P.O.A.D.P. PLAN for MEADOW VILLAGE SHOPPING CENTER

Re: Meadow Village

POADP # 584

The City Staff Development Review Committee has reviewed Meadow Village Subdivision Preliminary Overall Area Development Plan # 584. Please find enclosed a signed copy for your files. Although your plan was accepted, please note the following:

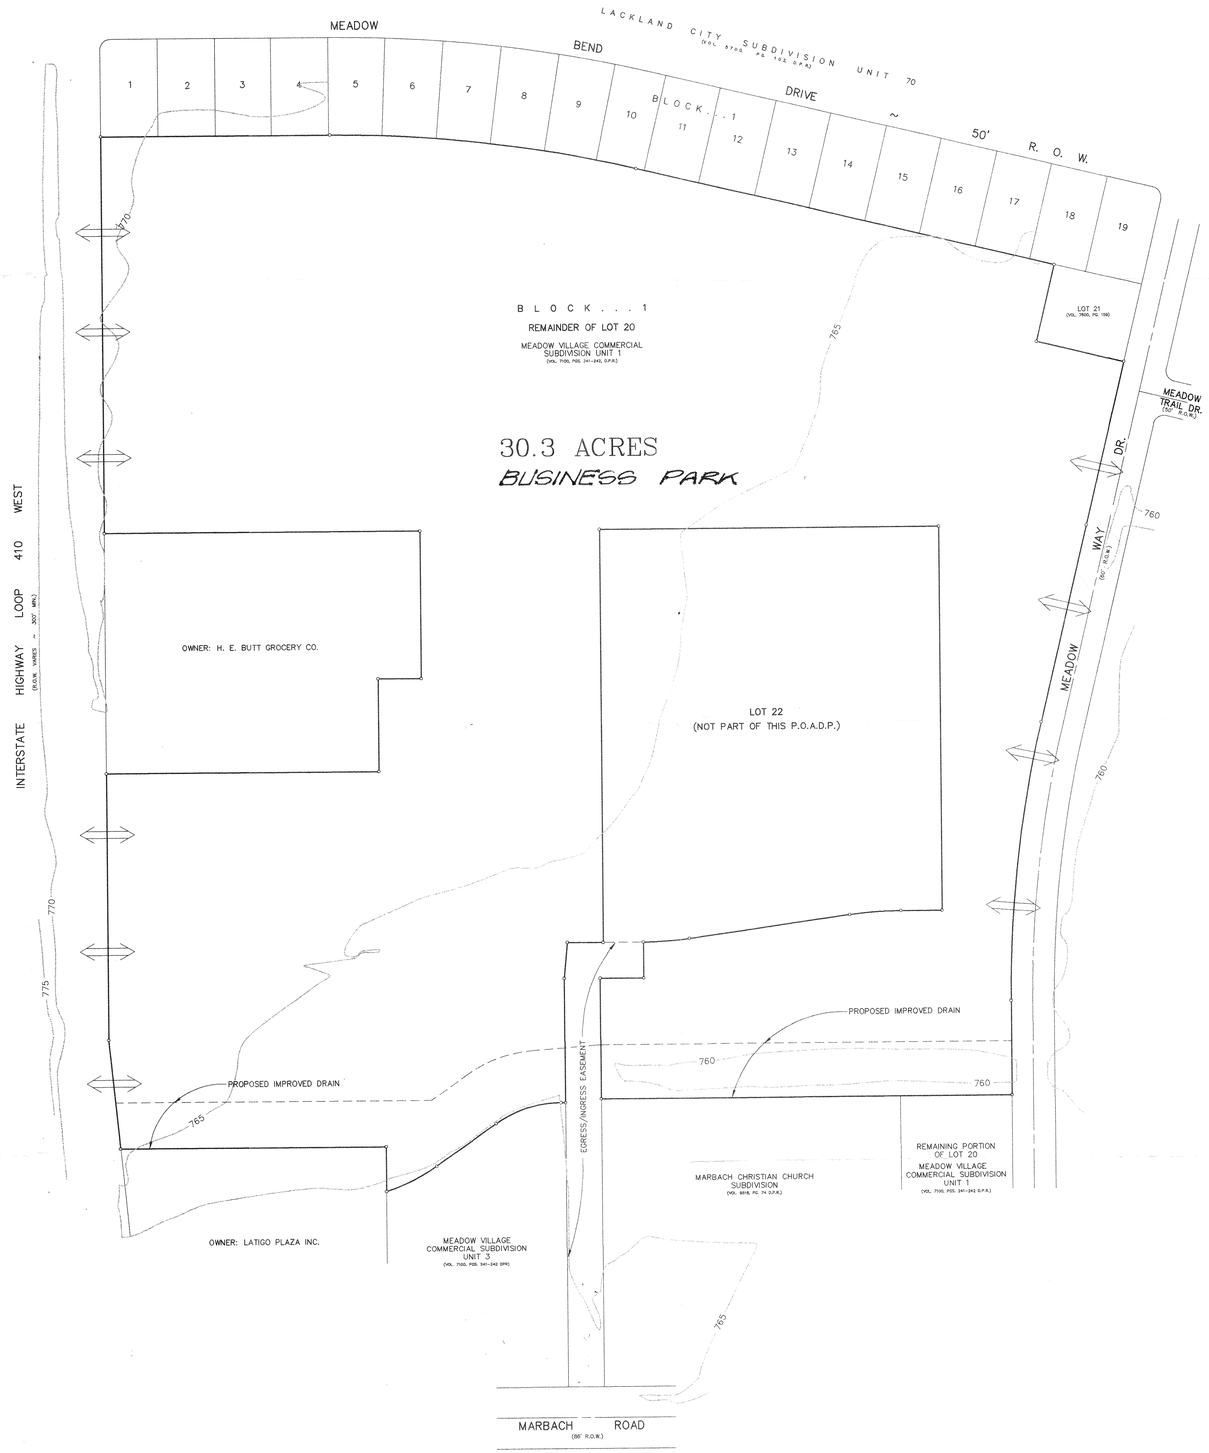
- Access and R.O.W. issues along State facilities will need to be resolved with the Texas Department of Transportation (TXDOT). For additional information about these requirements you can contact TXDOT at 615-5814.

- Based on the topography, a Flood Plain Study and drainage review will probably be required during the platting process.

- Meadow Way is a will require a total of 60′ of ROW.

- This development will need to comply with tree preservation ordinance #85262. For additional information about these requirements you can contact Building Inspections at 207-7102.
